WEST UTILITY PLANT

**THE COLLEGE OF WILLIAM & MARY**
WILLIAMSBURG, VIRGINIA

HW & CHW DISTRIBUTION PLAN

MS2.01

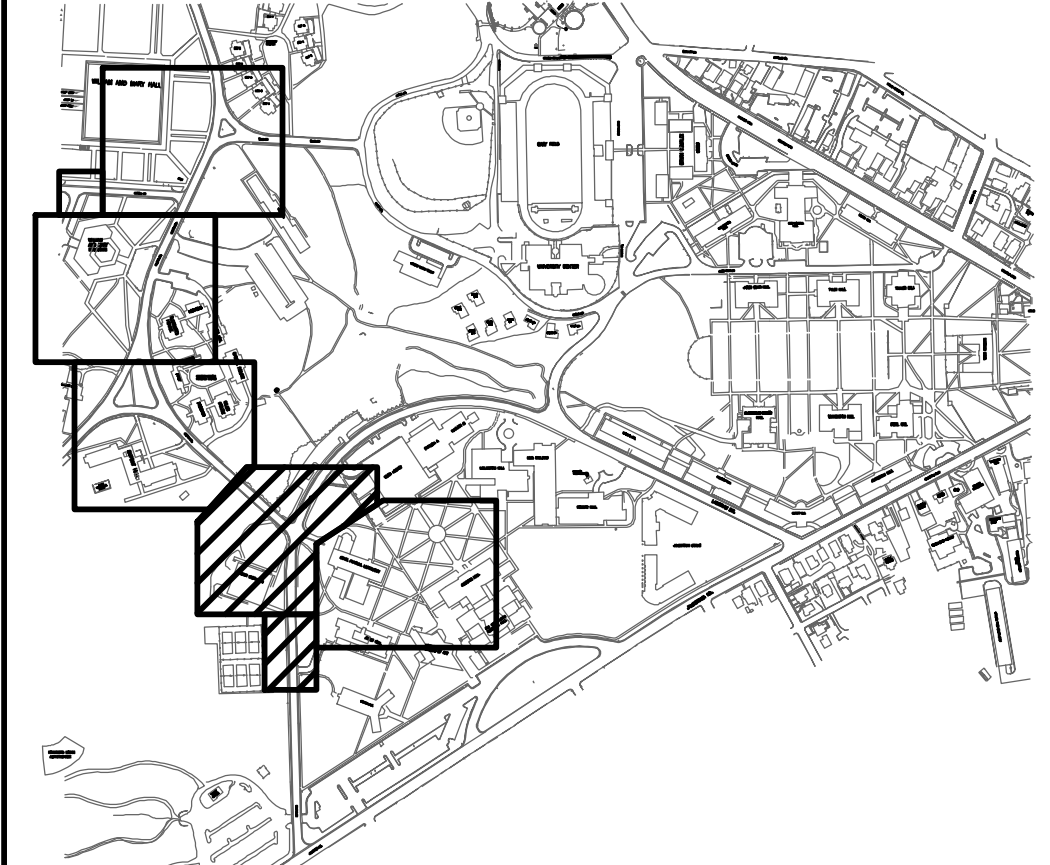
12/19/19 through 01/16/20 both lanes shutdowns for final tie-ins and road pavement repair, no access across bridge for bridge abutment work at the east end of bridge

This shutdown will need to be approved by fire and police dept. since Ukrop Way will be shutdown during this time(12/19 - 1/16).

Phase 2 work will impact DPR's ability to access current lay down area at Kaplan Arena and we have assumed a section of the north parking lot will be shutdown from 12/19/19- 01/16/20 to support WUP Ukrop Way scope of work material lay down.

12/2/19 through 12/18/19 (one lane open), lane closure to extend from intersection North of the WUP through the West side of the bridge to allow for material staging and ensure civilian safety.

*Phase 2 schedule is independent of the WUP schedule. West Utility schedule remains as the primary schedule and no schedule impacts from phase 2 have been accounted for.
